RE: **Iron Duplex**
1203 Iron SW
Grading and Drainage Plan
Engineers Stamp Date 11/22/16 (K13D074)

The purpose of this letter is to accompany the enclosed grading plan. The plan has been revised to address your email comments dated 11/21/16. Below are your comment and our response as to how they were addressed are underlined:

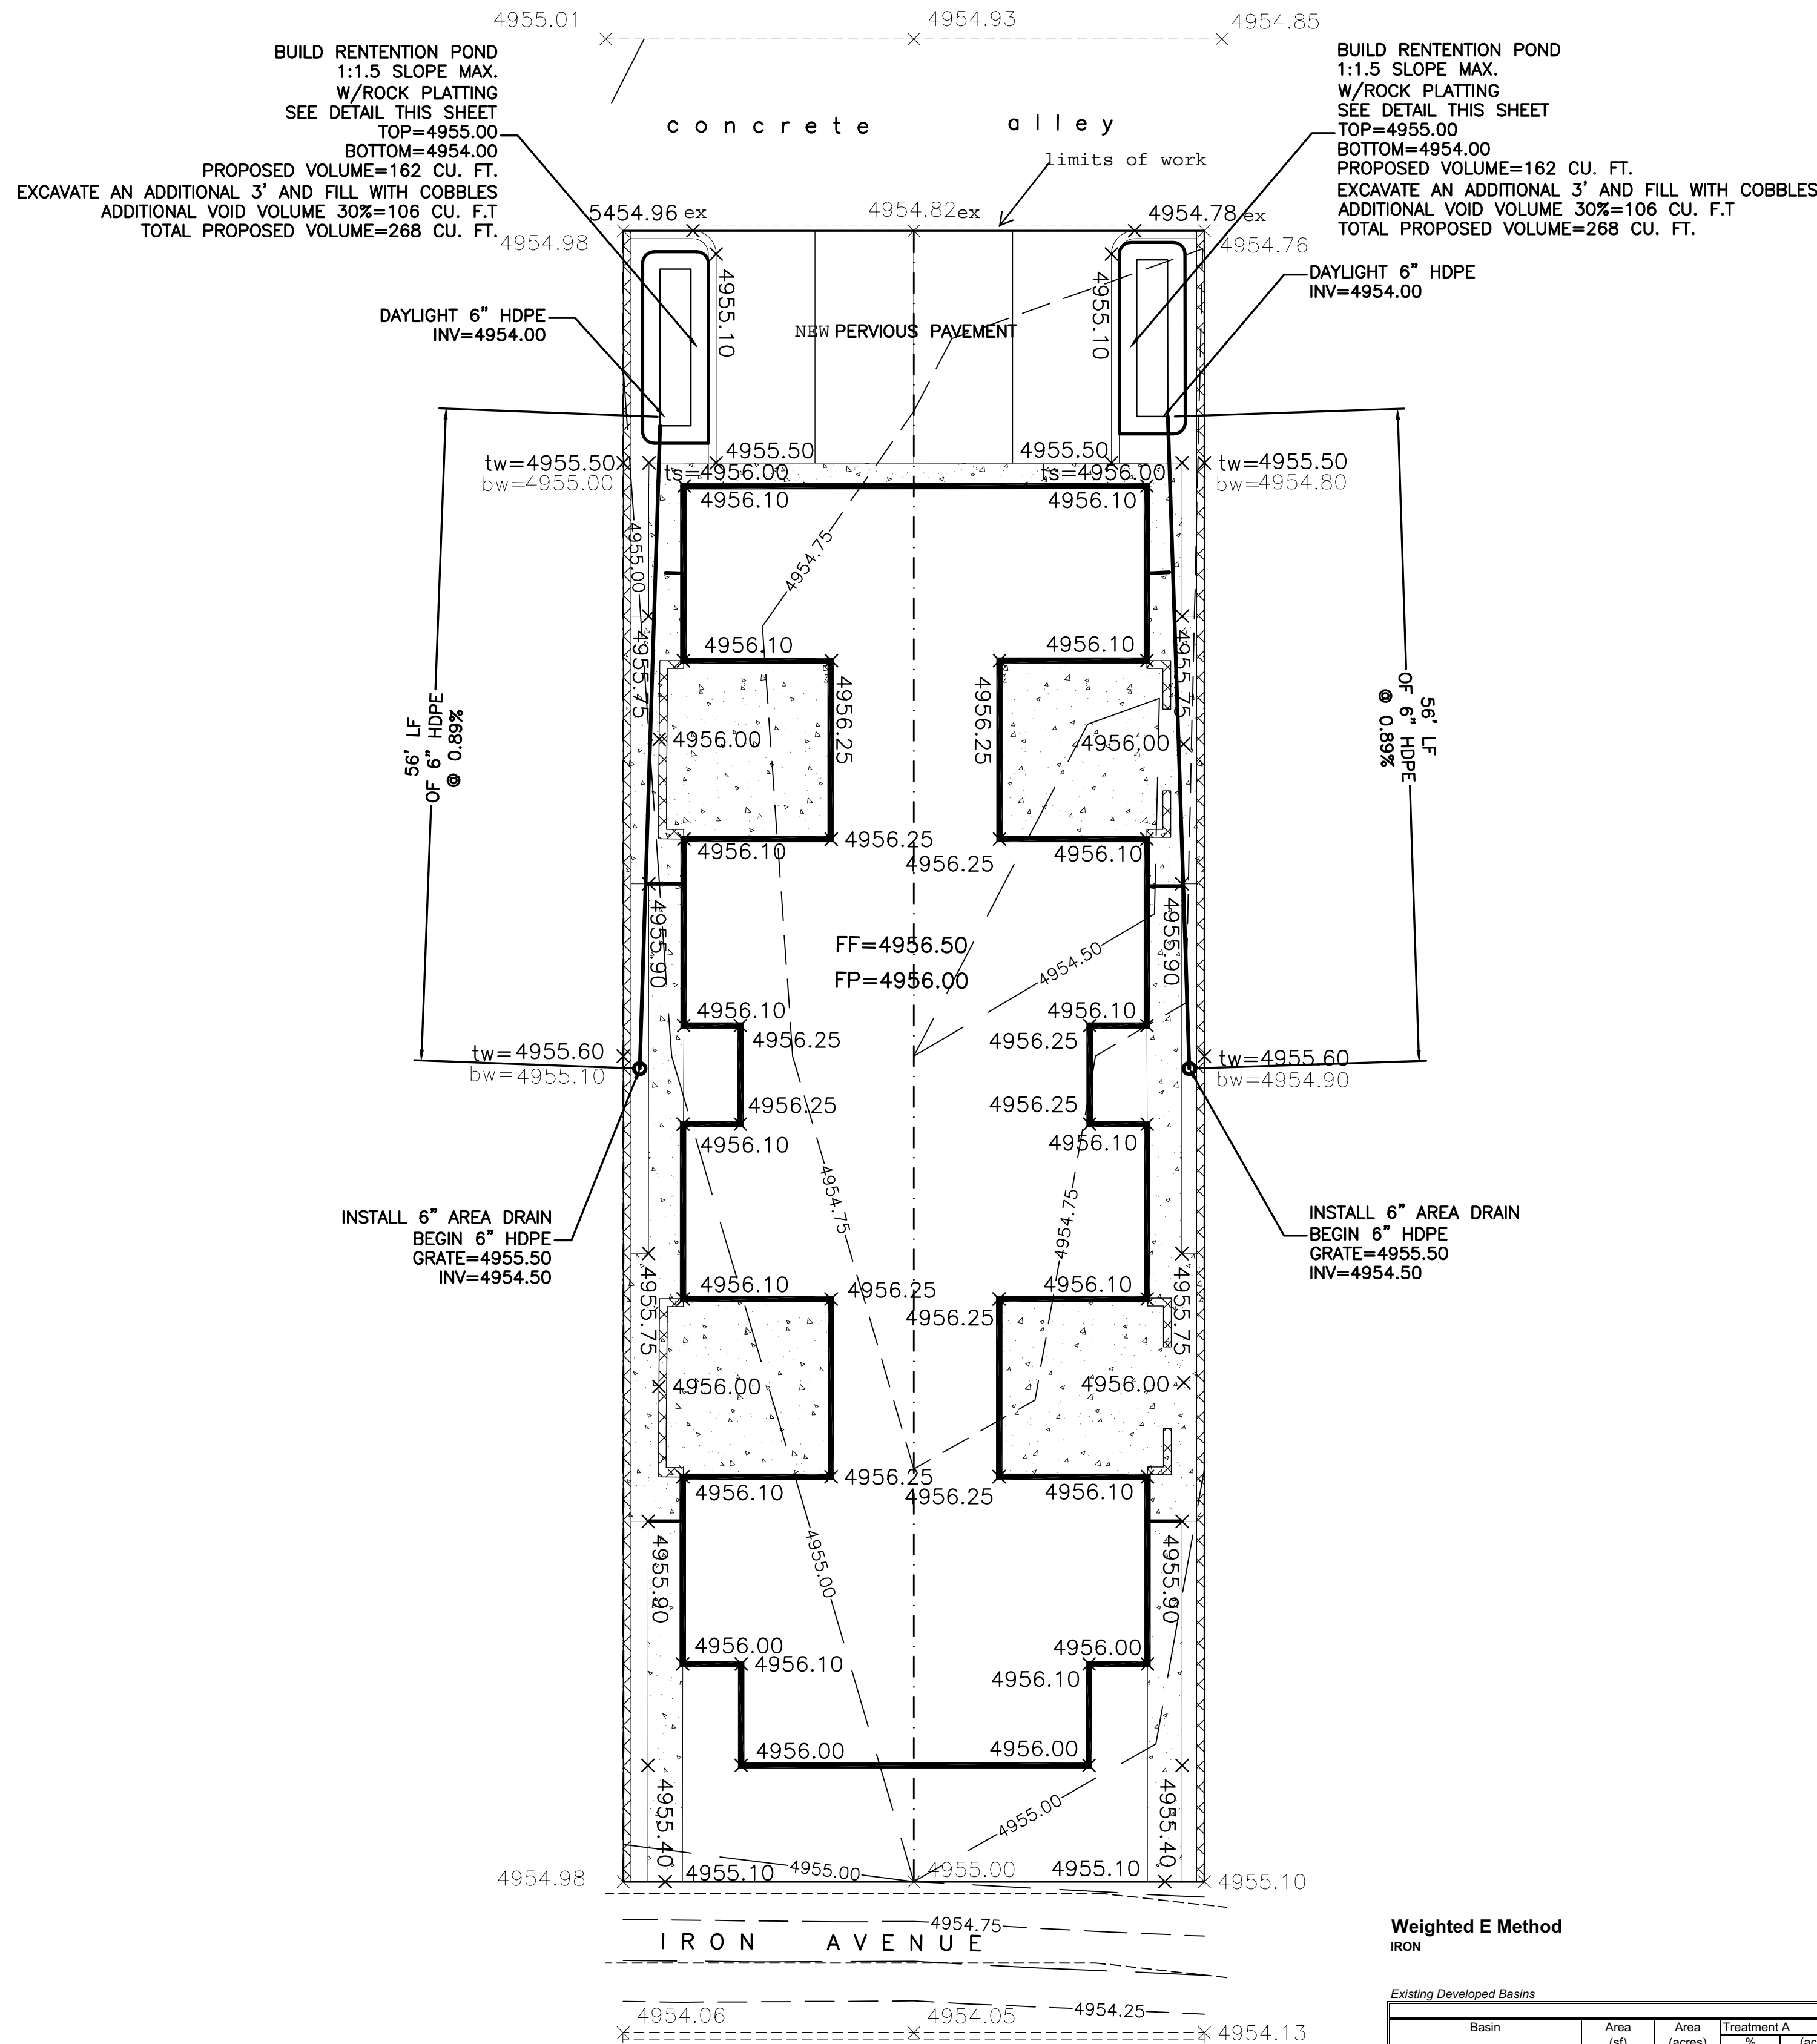
1. Clarify the contour and surface work to be completed adjacent to the alley.
 - a. The linework suggests that parking spots are to be developed, are they paved? .
We have added limit of work area and labeled the treatment of the parking spaces.
 - b. The contours of the pond seem to grade the pond off center, steepening the side slopes adjacent to the parking lot.
We have revised the contours to center the pond.
2. The concrete alley appears to be cracked throughout its length. The contractor will be required to sawcut and repair those portions of the concrete alley that are degraded by the construction of the improvements.

We have added this note #3
3. The site is zoned SU-2, does the project need Site Plan approval?
We understand that the SU-2 zone requires site plan approval by the planning director. The builder has initiated this process and we believe this has been approved.
4. How does the roof drain? It should not discharge directly onto the sidewalk.
We have identified the roof drains and added a trench drain (note#4)
